Access Compliance Report

Public Rights-of-Way

Intersection ID: 9791	Main Street: N_TRYON_ST	Cross Street: W_30TH_ST	Location: W
ADA ID: 15DFFF274A0D	Ramp Type: PerpDiag	Initial Pass/Fail: Fail	Overall Compliance: No
			Severity Score: 50

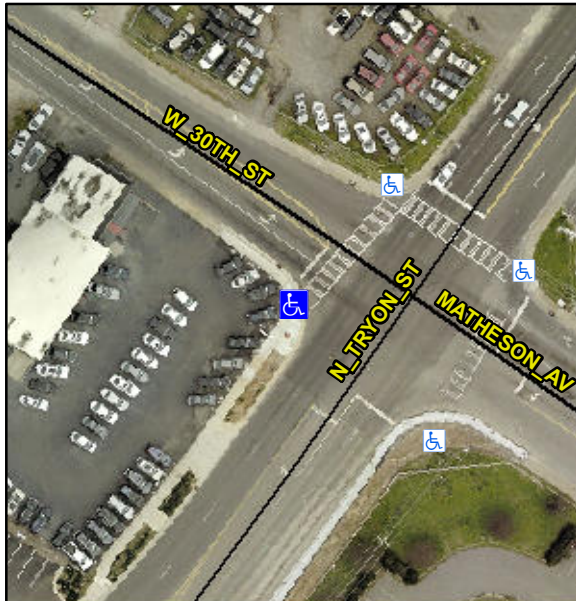
R304.2.2, R304.5.3

Compliance	Description	Data	Compliance	Description	Data
N/A	Ramp Length (in)	60.0	No	Ramp Slope (%)	13.4
Yes	Ramp Width (in)	48.0	No	Ramp XSlope (%)	9.5
N/A	Flare Type LT	N/A	N/A	Flare Type RT	N/A
N/A	Flare Slope LT (%)	N/A	N/A	Flare Slope RT (%)	N/A
N/A	Flare Traversable LT?	N/A	N/A	Flare Traversable RT?	N/A
N/A	Landing Length (in)	N/A	N/A	DWS Provided?	N/A
N/A	Landing Width (in)	N/A	N/A	DWS Contrast?	N/A
N/A	Landing Slope (%)	N/A	N/A	DWS Length (in)	N/A
N/A	Landing X Slope (%)	N/A	N/A	DWS Full Width?	N/A
N/A	Landing Curb? (Y/N)	N/A	N/A	DWS Offset (in)	N/A
N/A	Shared Landing?	N/A			
N/A	Gutter Ponding?	N/A	N/A	Gutter Slope (%)	N/A
N/A	Gutter Lip Ht (in)	1.0	N/A	Gutter X Slope (%)	N/A
N/A	Painted X Walk1?	No	N/A	Painted X Walk2?	Yes
	X Walk 1 Direction	To SE		X Walk 2 Direction	To NE
N/A	X Walk 1 Width (in)	N/A	N/A	X Walk 2 Width (in)	132.5
	X Walk 1 Slope (%)	3.6		X Walk 2 Slope (%)	2.7
	X Walk 1 X Slope (%)	2.9		X Walk 2 X Slope (%)	4.0

Remove & Replace Curb Ramp With Two New Directional Ramps or Equivalent.
